HISTORIC AND DESIGN REVIEW COMMISSION

June 07, 2017

HDRC CASE NO: 2017-249
ADDRESS: 445 DEVINE ST
LEGAL DESCRIPTION: NCB 2957 BLK 1 LOT 12
ZONING: R-5 H
CITY COUNCIL DIST.: 1
DISTRICT: Lavaca Historic District
APPLICANT: Mauricio Namé
OWNER: Carlos Namé
TYPE OF WORK: Construction of a rear addition, exterior modifications, new 2-story rear accessory structure, hardscaping

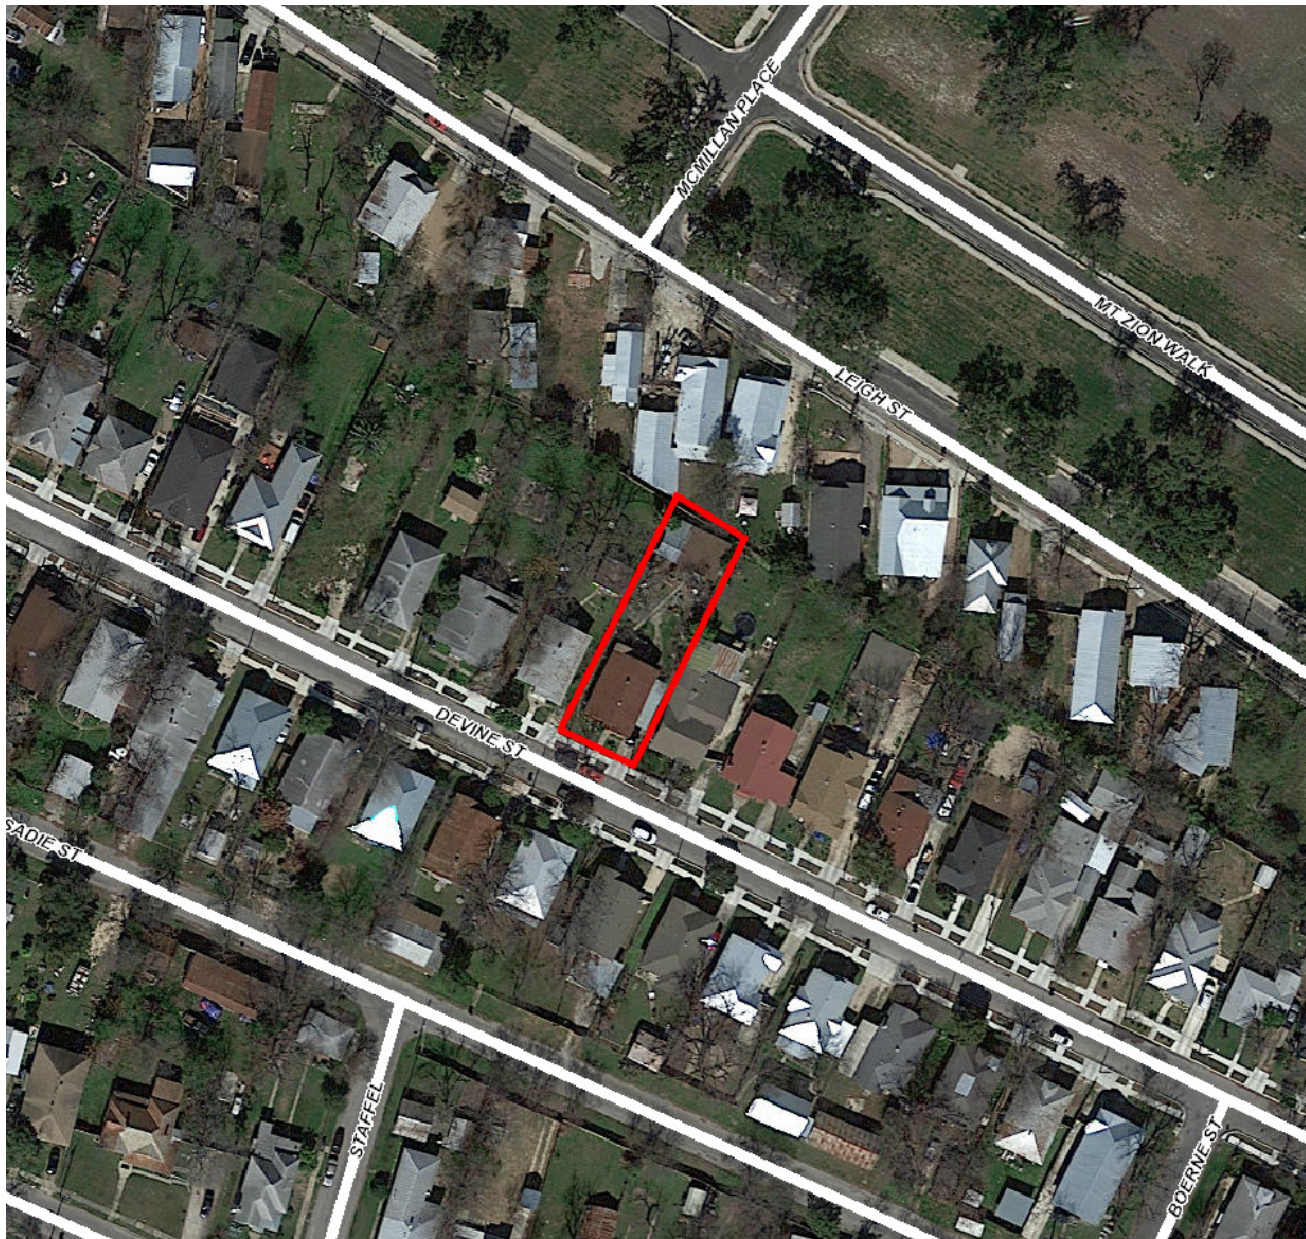
- i. That the applicant lower the ridgeline of the addition to be below that of the primary structure, per one of two potential design approaches submitted.

PROPOSED FLOOR PLAN

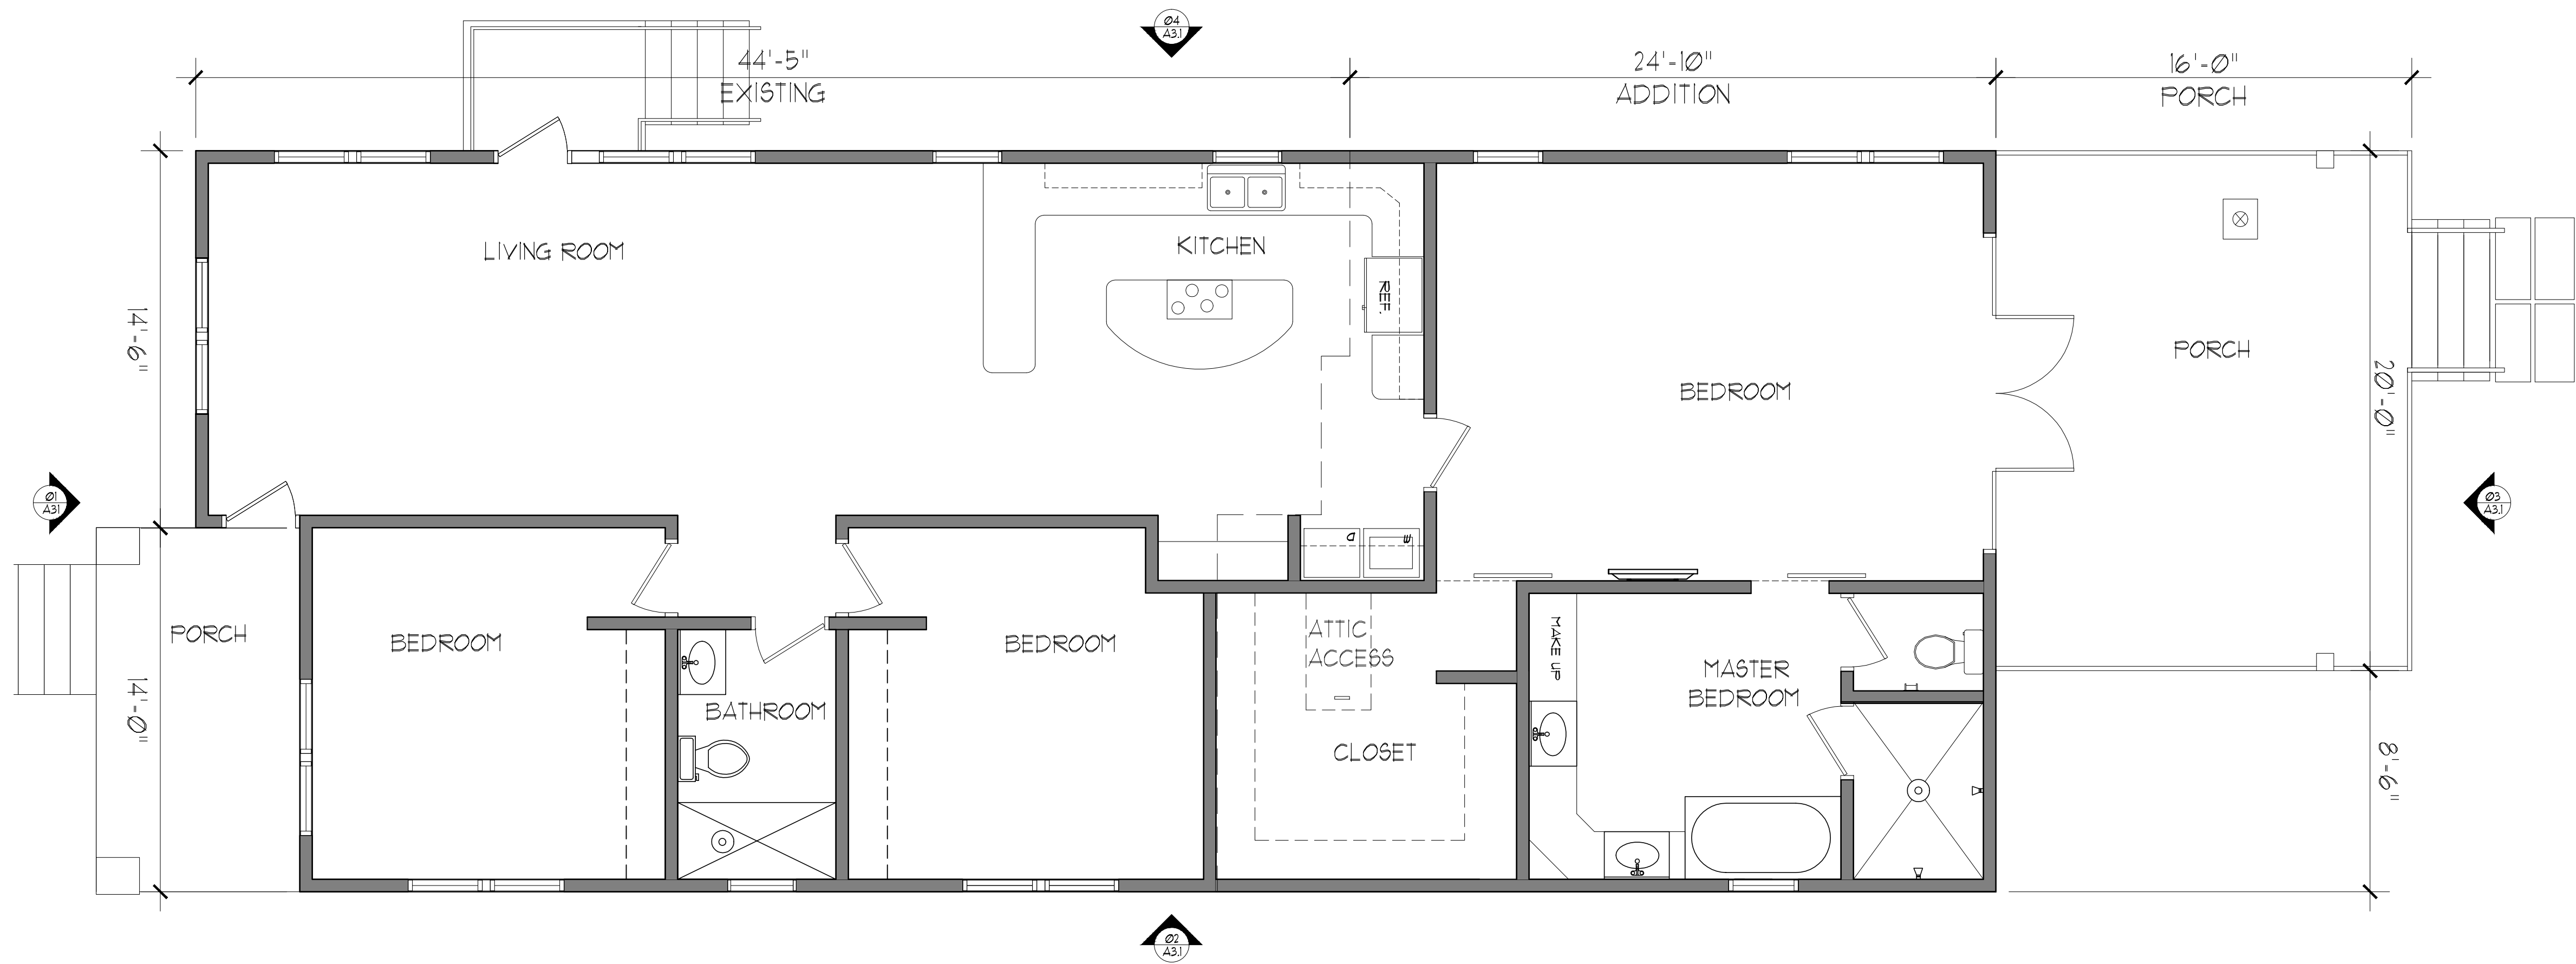
- c. **MASSING & FOOTPRINT** – The applicant has proposed to construct a rear addition to the primary structure. According to the Historic Design Guidelines, additions should be located at the rear of the property whenever possible. Additionally, the guidelines stipulate that additions should not double the size of the primary structure. The addition is approximately 70% the overall size of the existing home. Staff finds the proposal consistent with the Guidelines.

- g. **REAR WINDOW AND DOOR REMOVAL** – The proposed addition will require the removal of four one over one wood windows and one rear door. Guideline 3.C.i in the Historic Design Guidelines for Additions encourages the salvage and reuse of historic materials, where possible, that will be covered or removed as a result of an addition. Staff finds the proposal acceptable with the stipulations included in staff's recommendations.

Item 1, Staff recommends approval of the rear addition based on findings a through m with the following stipulations:
